Revised to 4 Bedrooms

APPLICATION FOR PERMIT TO CONSTRUCT/ALTER/REPAIR
AN INDIVIDUAL SUBSURFACE SEWAGE DISPOSAL SYSTEM

From: Paul Pogorzelski [paulpogo@hopewelltwp.org]
Sent: Monday, June 14, 2010 5:32 PM
To: 'George Kiesel'
Subject: Septic Design Review Blk 61 Lot 42

From: Paul Pogorzelski [paulpogo@hopewelltp.org]
Sent: Monday, July 12, 2010 8:27 AM
To: gkiesel@hopewelltp.org
Subject: Revised Septic Design Review B61 L42

LAY-OUT DISPOSAL BED

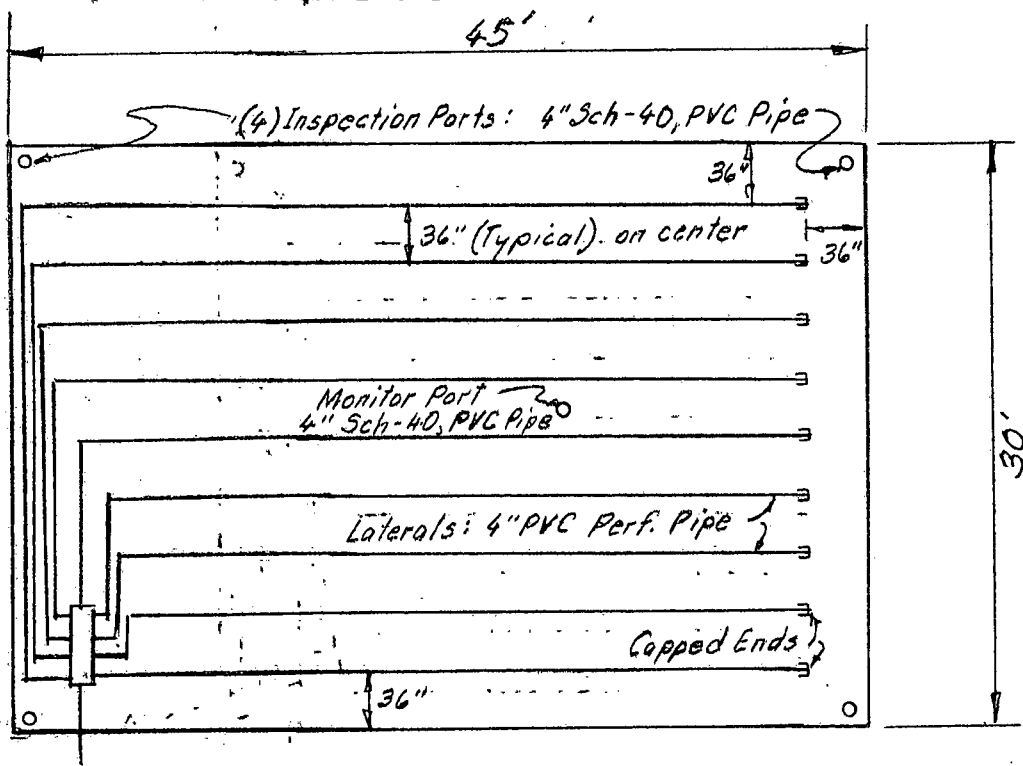
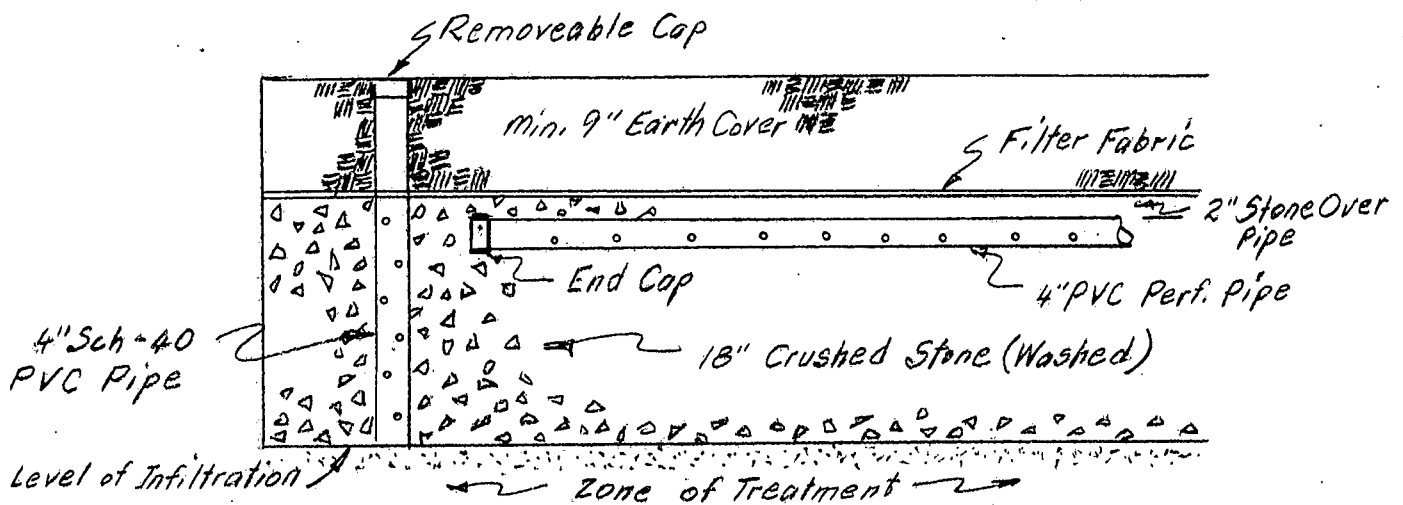
Revision	Date	By	Donald Mauer Jr. Professional Engineer 262 Schoolhouse Road, Jacobstown, NJ 08562 Phone No. 609 758 6945		 5/19/11
Enlarged Disposal Bed	4-15-11	FJM	Client: Nigel Newton 219 Pleasant Valley Rd, Titusville		
			Scale: 1"=30'	Drawn By: FJM	
			Date: June 7, 2010	Checked By: DM	
			Title: Septic System	Block: 61	
			Lot: 42	Municipality: Township of Hopewell	GE02823100 - Sheet // of 5

Designed Disposal Bed $30' \times 45' = 1,350.0 \text{ sq. ft.}$

CROSS SECTION DISPOSAL BED

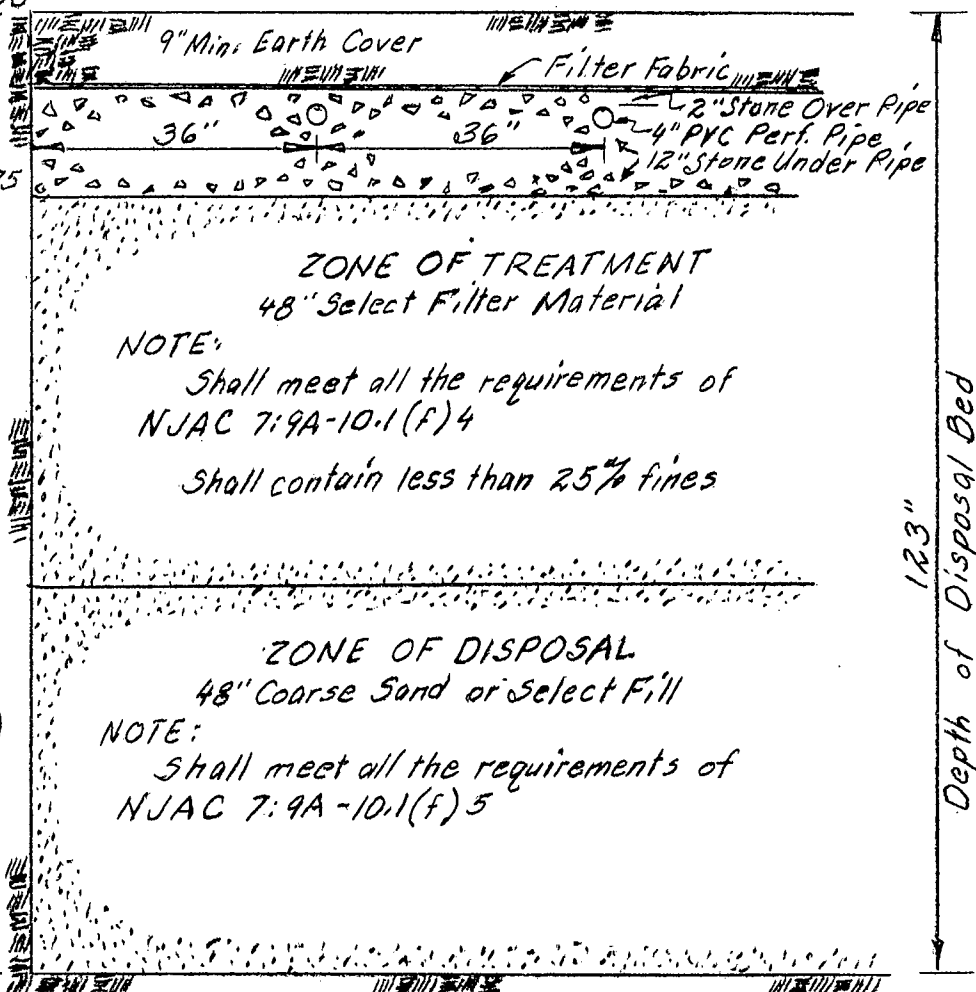
Elevation of sewer line MUCH lower than anticipated.

System Revised to Pressure Dose w/ Pump Tank added. Per Frank Morzella.

* Tank ~~Size~~ Sized not adequate for 5 Beds.

Revised Plans reflectly changed made -
As-Built, send cert, + cert of compliance

DESIGN
DATE: 7/8/10
HOPEWELL TOWNSHIP HEALTH DEPT.
APPROVED

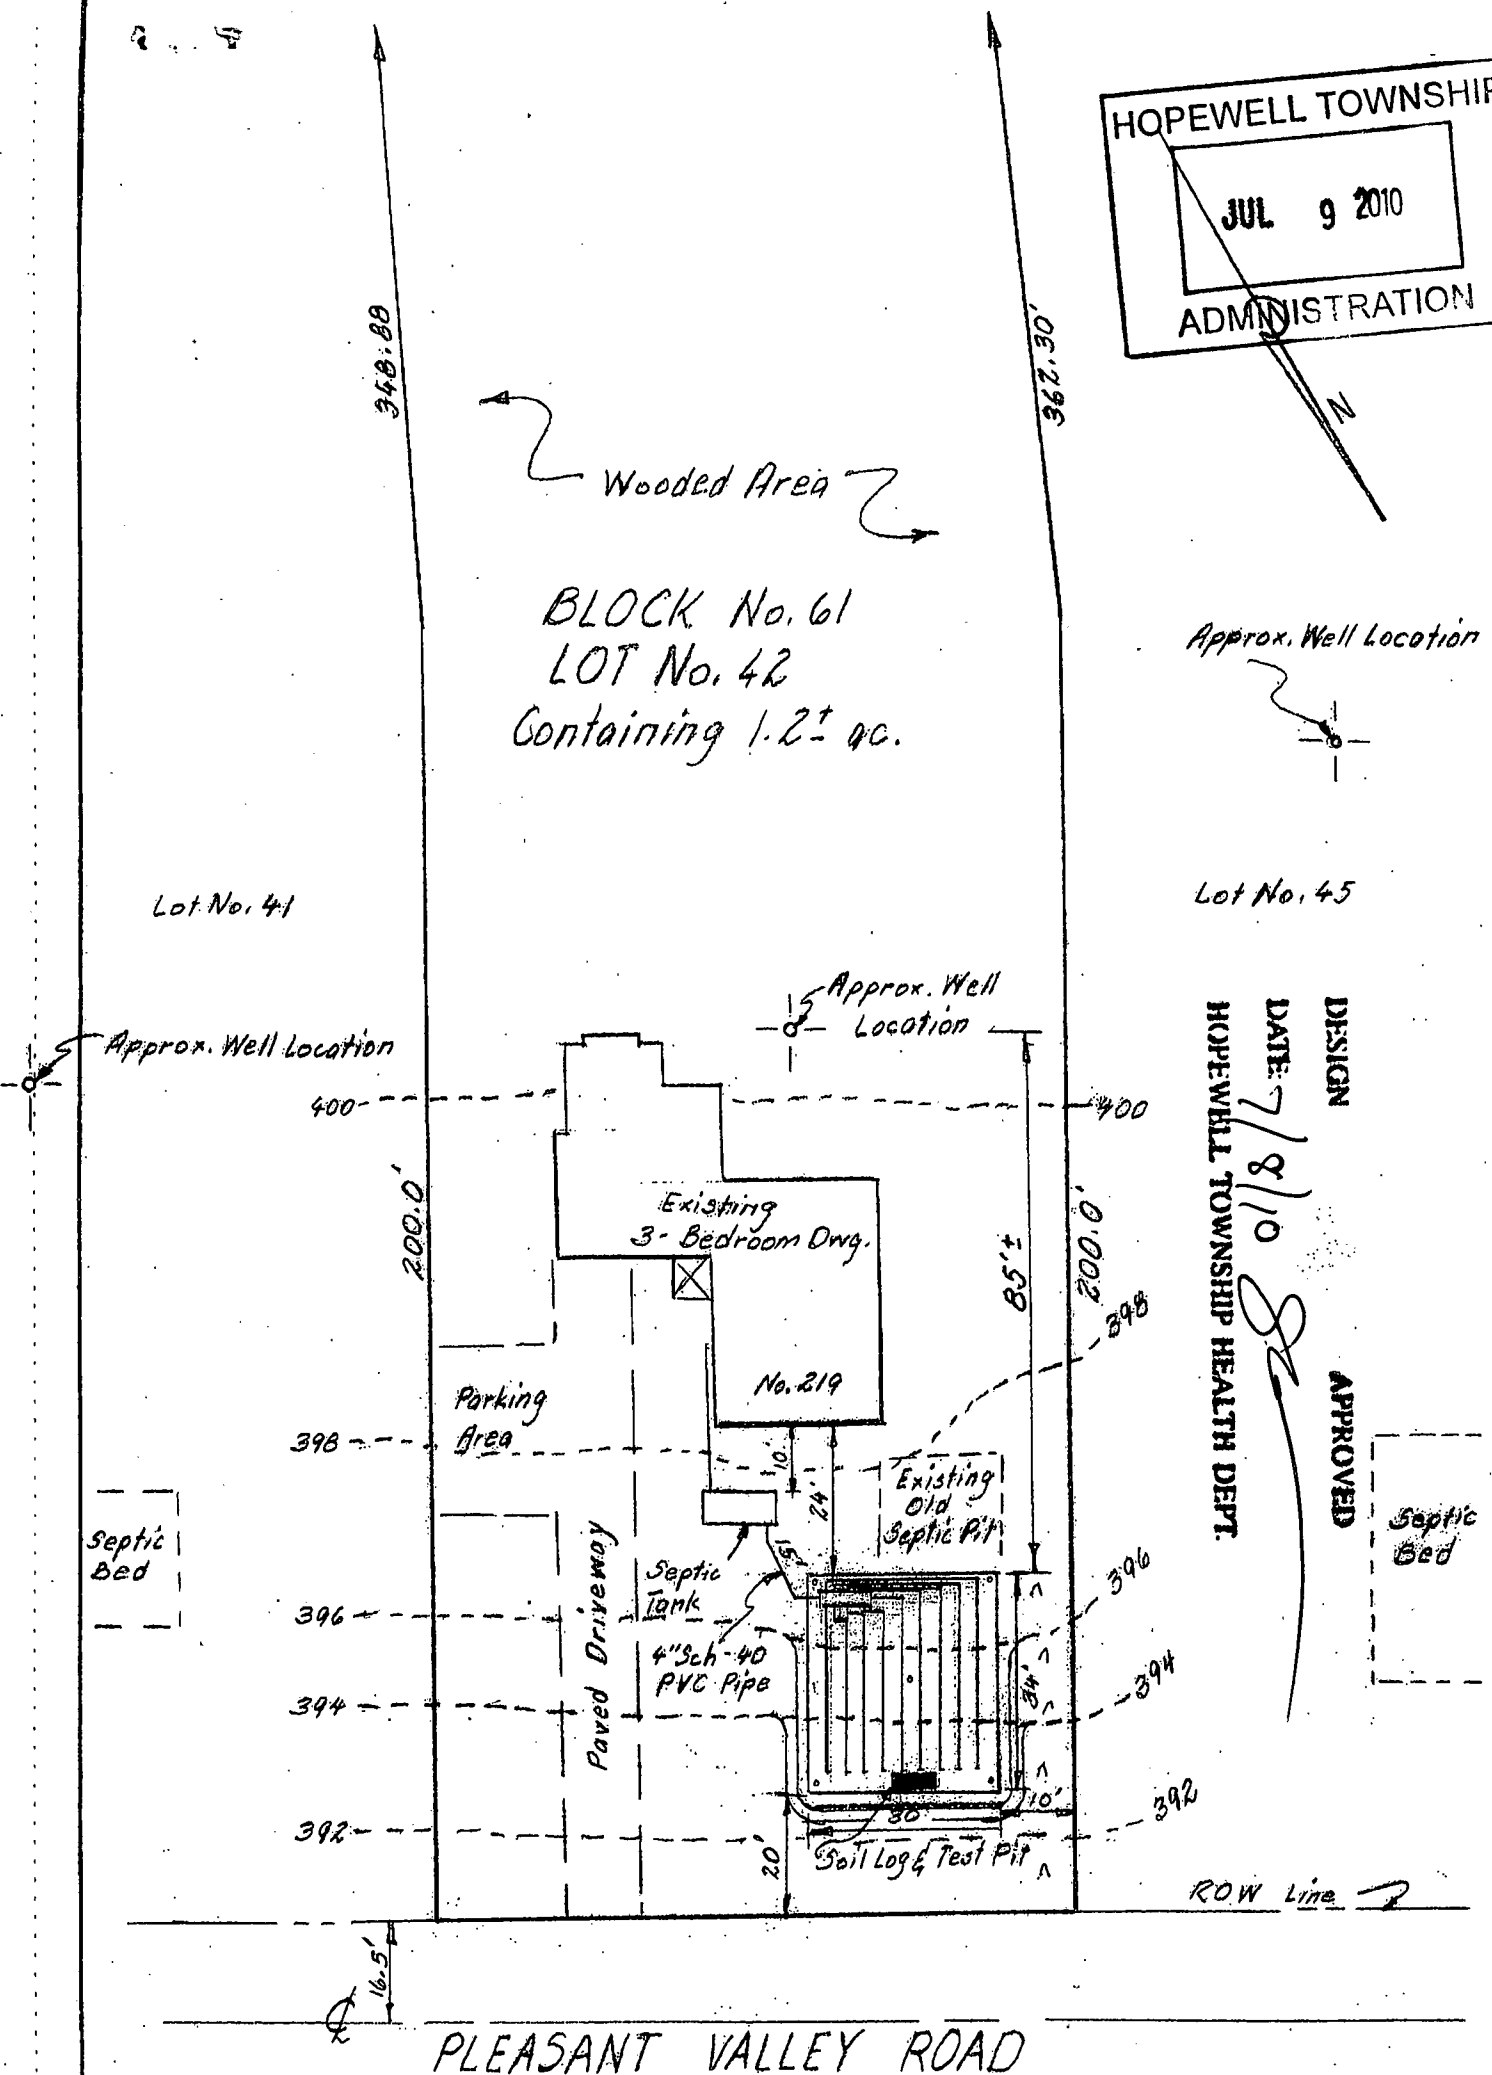
Grading along NE property line appears to concentrate runoff onto neighboring lot. Revised grading in this area.

Approved
